GENERAL

This addendum forms a part of the Contract Documents and modifies the original Bidding Documents dated February 2024 and consists of pages AD1-1 through AD1-3, PSSB Data As-Built and PSSB RCP As-Built. The following changes, additions and/or deletions shall be made to the following documents; all other conditions shall remain the same.

ITEM NO. I – RFI/CLARIFICATIONS

PATIENT SUPPORT SERVICES BUILDING
 UCD PROJECT NO. A/C 934990

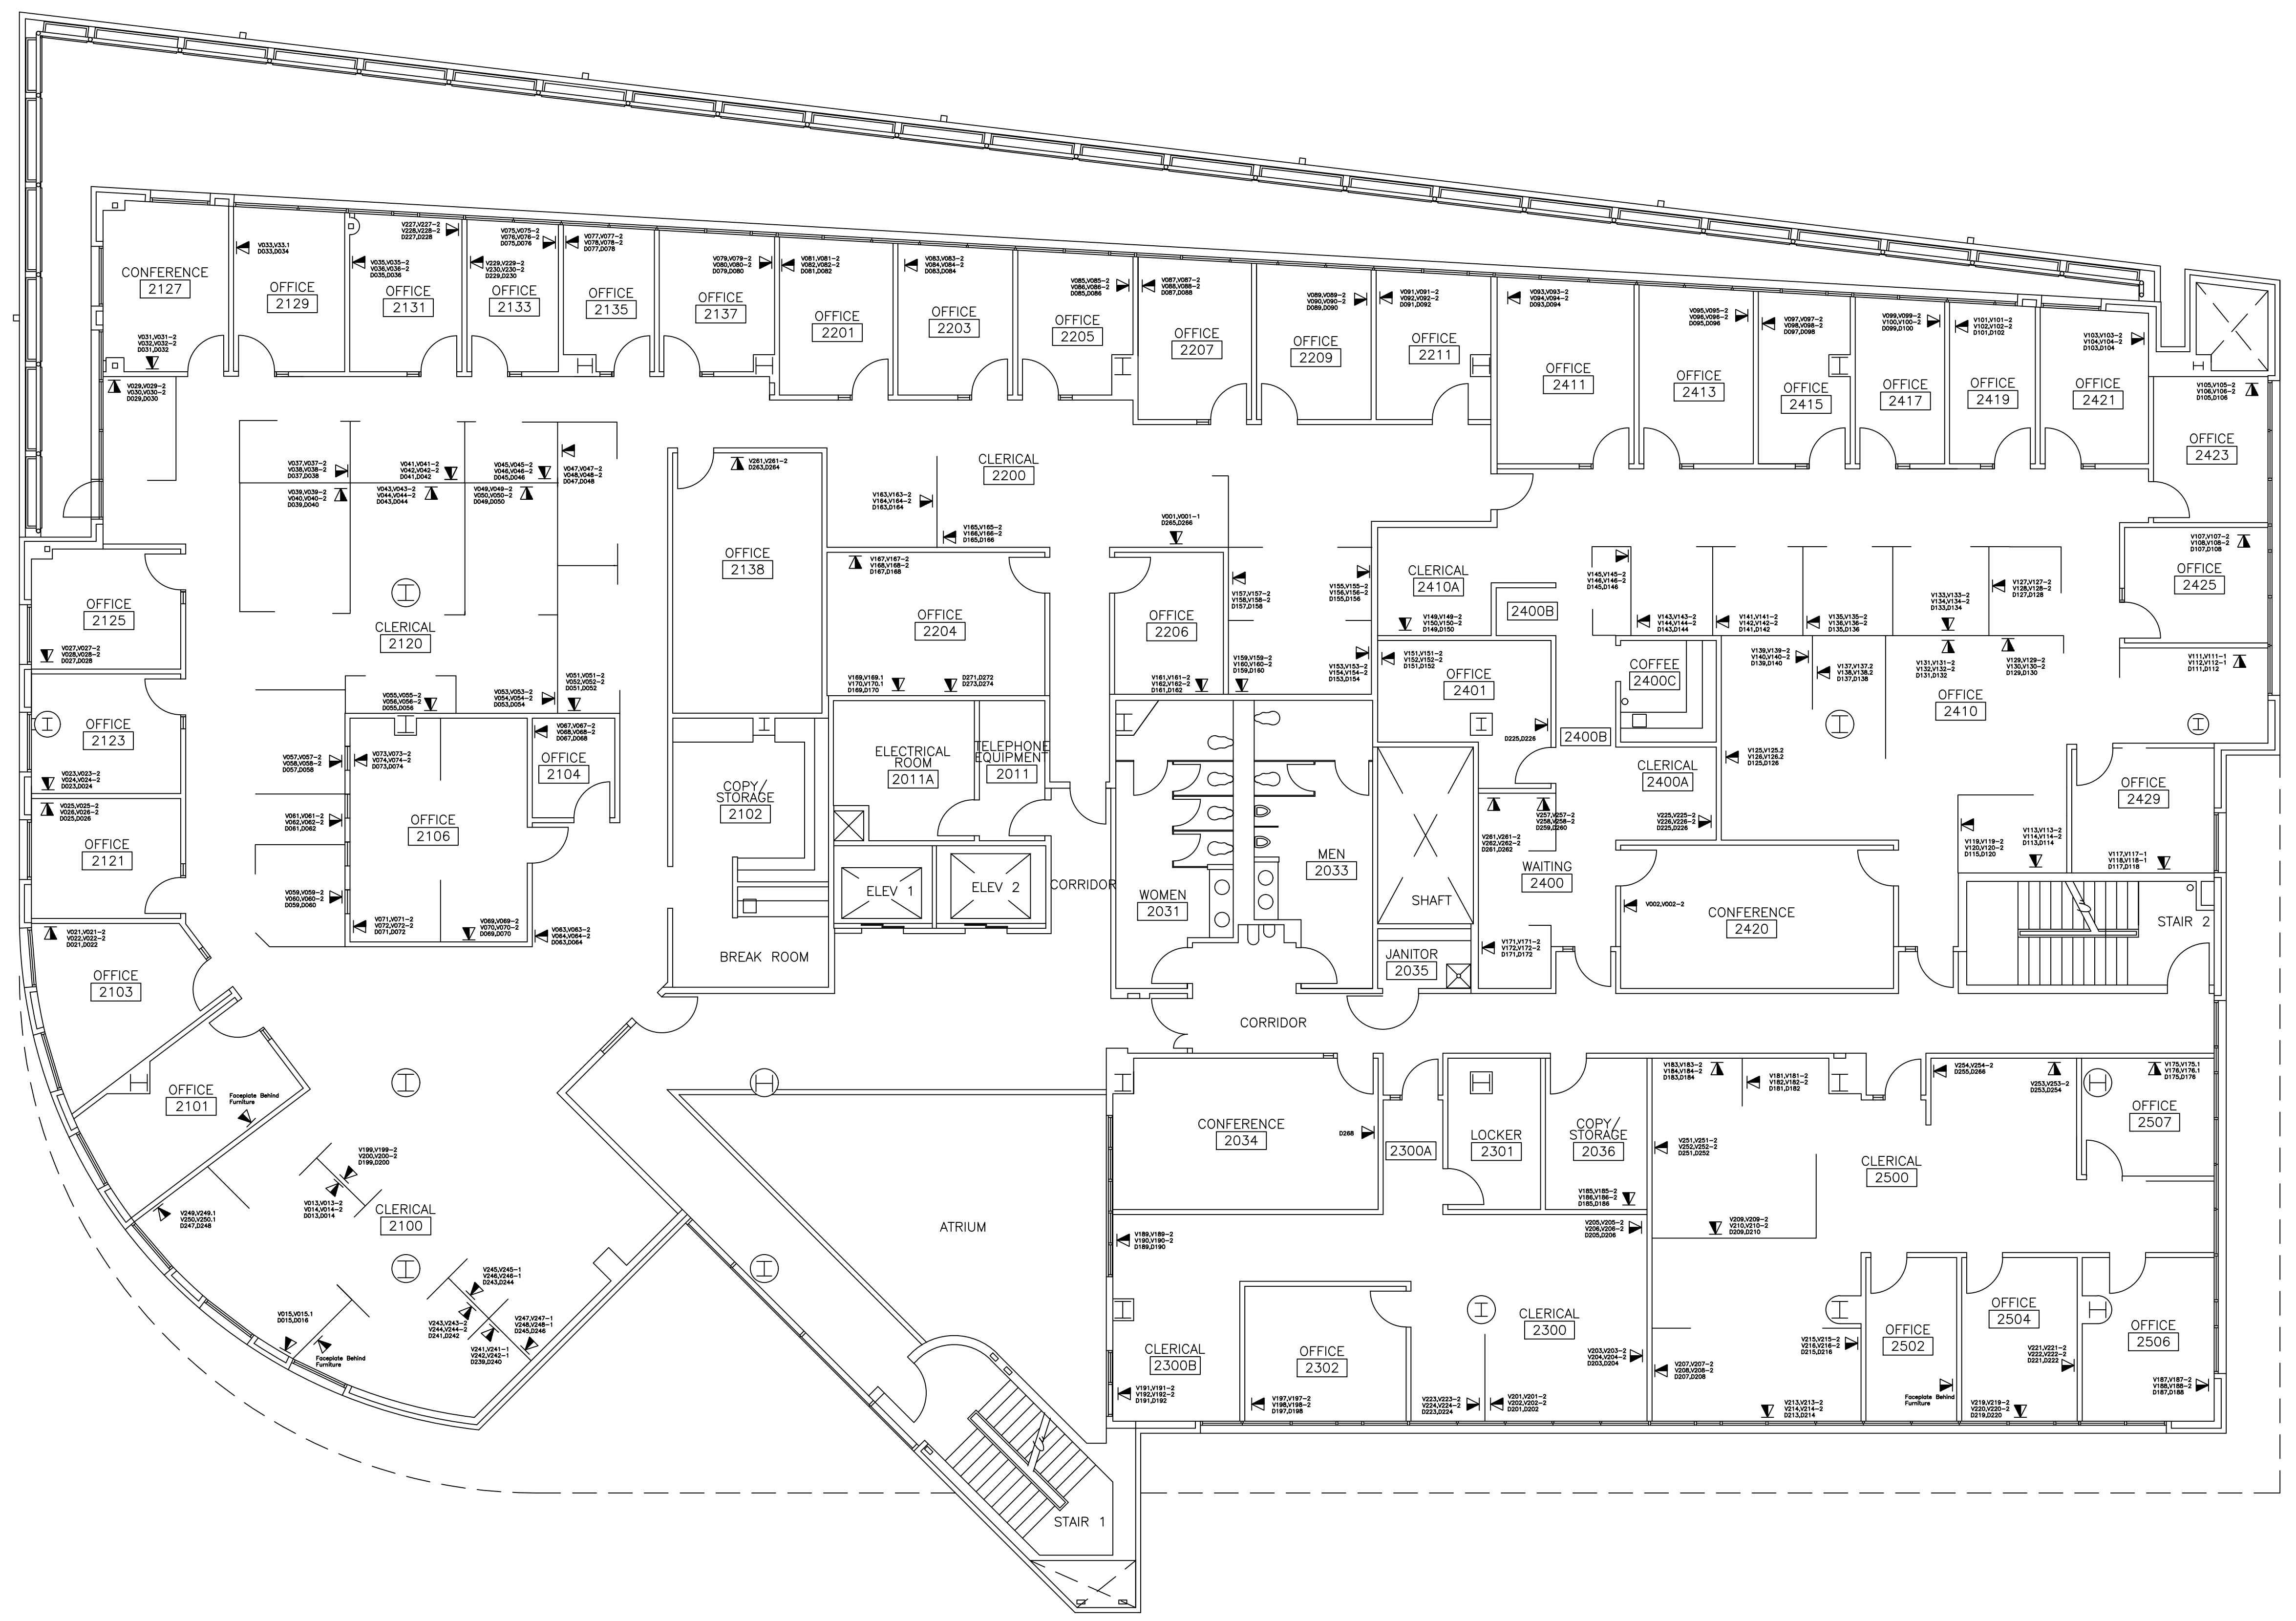
19. **Question:** Shall we assume that every existing faceplate has (1) voice cable?

Answer: There are existing voice cables to remain but the amount of data cables being removed and replaced should be roughly the same. See attached as-builts of the voice / data outlet terminations furnished for your awareness. Every outlet location will get have its data cables (typically 2-Cat5) removed and replaced with (2) Cat 6A cables. Independent voice cables will need to be replaced with a data cable to allow for VoIP.

Answer: See attached as-builts from UCDH IT for voice/data quantities at each outlet location. Keep in mind every location regardless of the number of voice/data drops is getting (2) replacement CAT6A data drops.
